Stage 03: Second Workgroup Consultation

Connection and Use of System Code (CUSC)

CMP237

'Response Energy Payment for Low Fuel Cost Generation'

Figure 1 - Wind holding price for Primary frequency response

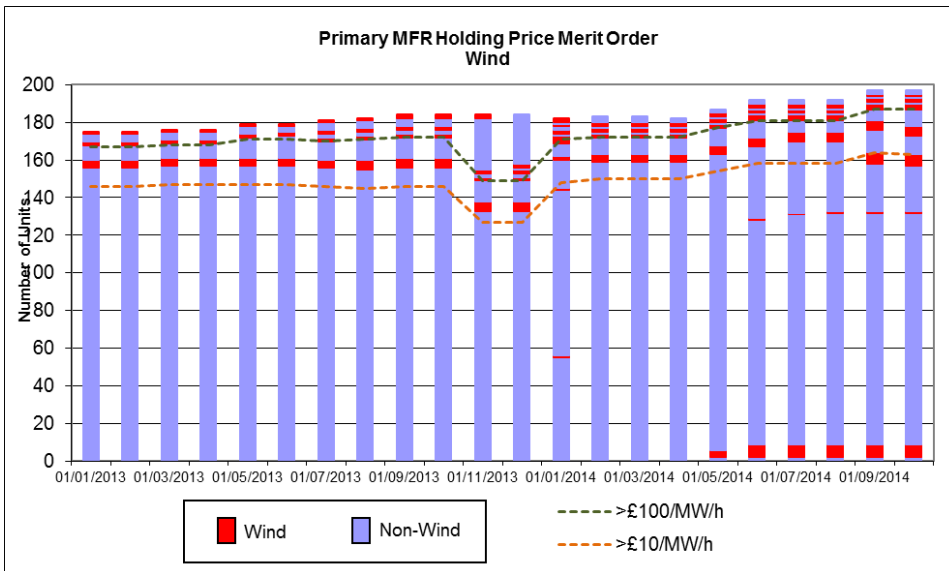
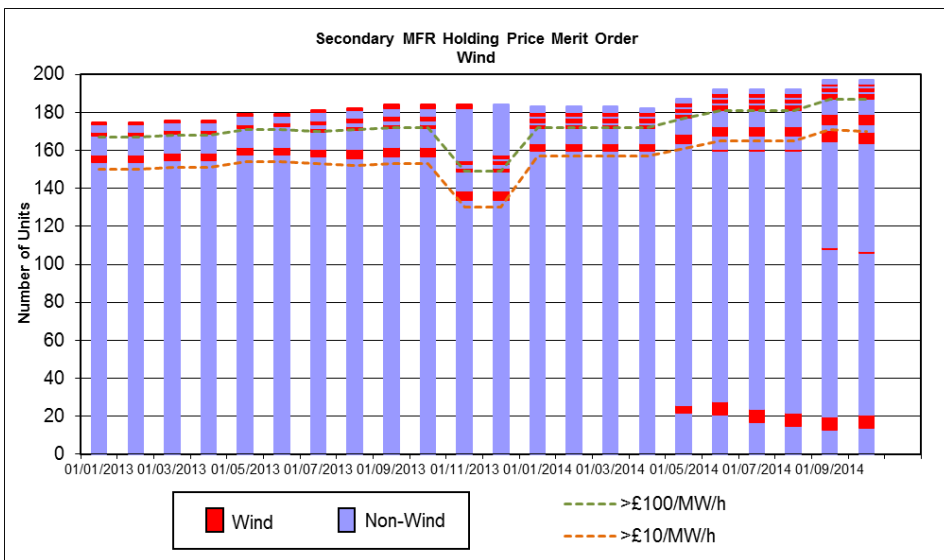
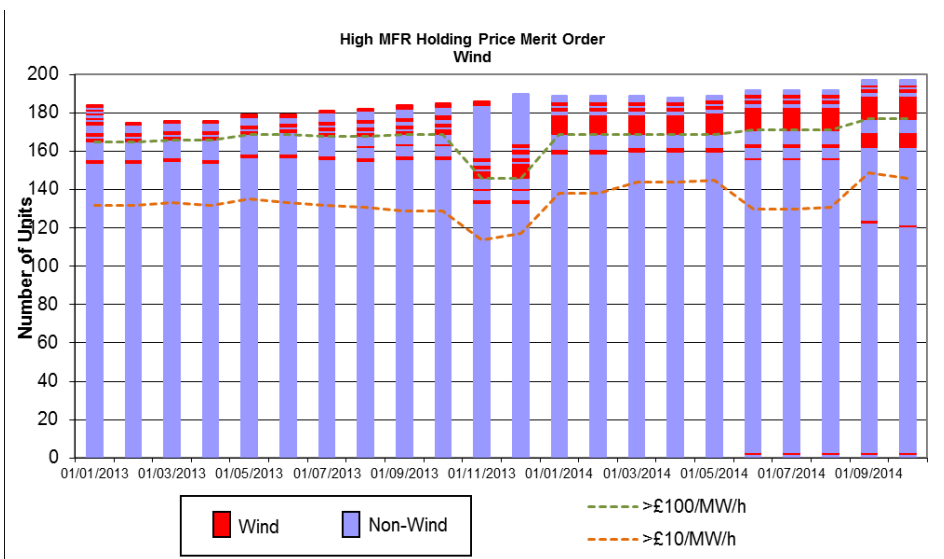
- 4.11 One Workgroup member noted that on all three graphs presented, there is an anomaly in winter 2013 where a larger proportion of plant submitted prices higher than £100/MWh and asked if there was any reason for this. The Proposer noted that after investigation, no clear reason could be found for the behaviour as the plants involved were CCGT and coal from several different companies in different parts of the country. This is the first year that the behaviour has been exhibited, and therefore it is suspected that the values may have been default inputs into the FRPS system.

Figure 4 - submitted holding prices per generator against the estimated BM cost to move the generator to the assumed most responsive point for the 30th September 2014

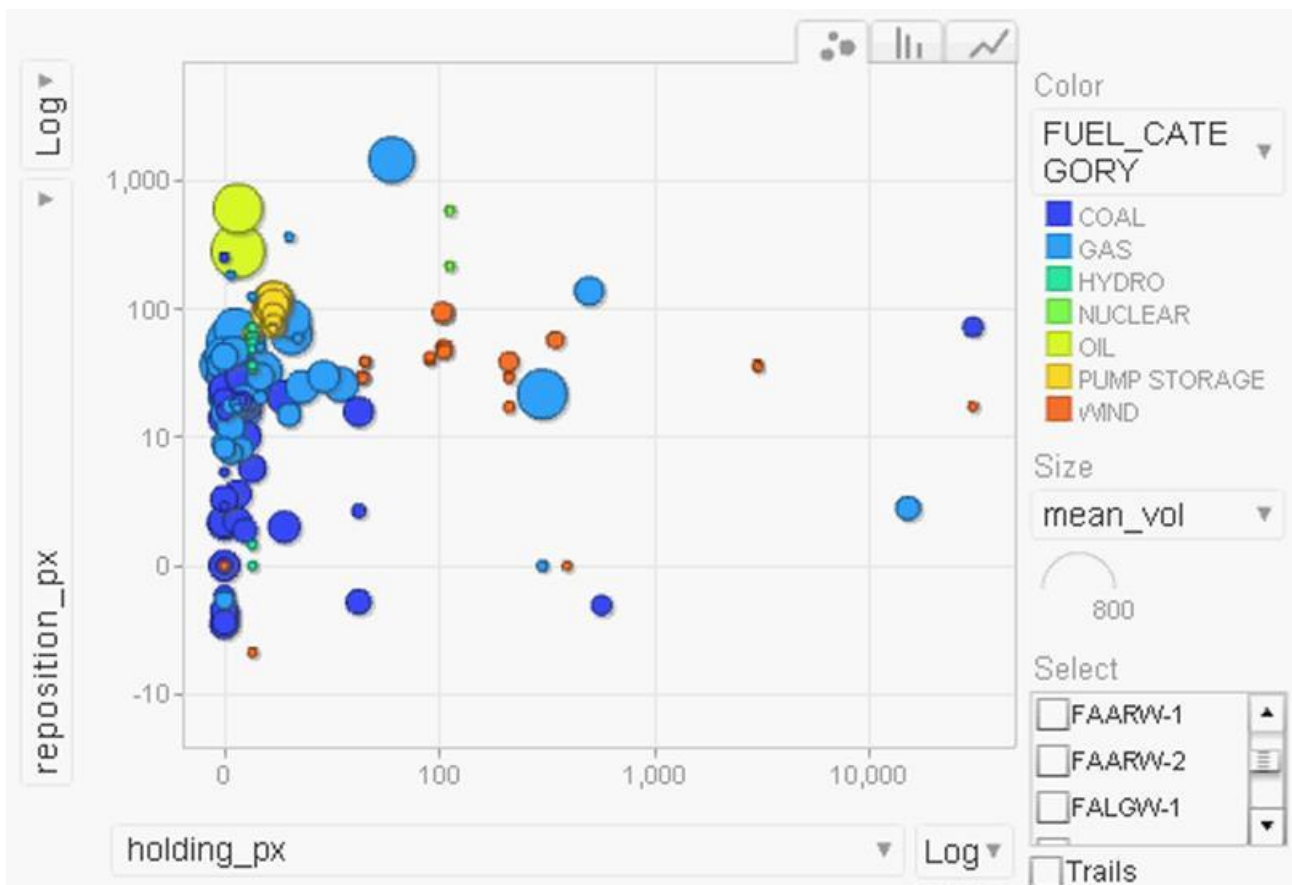
- 4.15 One Workgroup member noted that on fig 4 above, the general trend for generation with a fuel cost tended to follow the Y axis, whereas those without a fuel cost tended to follow the X axis. The Workgroup member stated that as hydro generation clearly following the Y axis like other conventional plant, this supported the view that they should be considered as having a fuel cost for the purpose of this Modification. It was noted, however, that there may be other reasons why a group of generators had similar holding prices; e.g. plant with similar construction may have similar sunk costs to recover, and that this was not direct evidence of the existence of a short-term fuel cost.

The competitive situation is most starkly shown in Figure 4 of the consultation document. This shows that hydro generation competes with other mandatory frequency response service providers (which are classified (artificially) for the purposes of CMP237 Original as ‘fuel cost’ such as coal, gas, nuclear, pump storage and oil) via the holding payment and REP. Figure 4 shows hydro generation clustering with the ‘fuel cost’ generation along the vertical. In stark contrast to this, wind generation can clearly be seen along the horizontal and no clustering pattern with ‘fuel cost’ generation can be easily discerned.
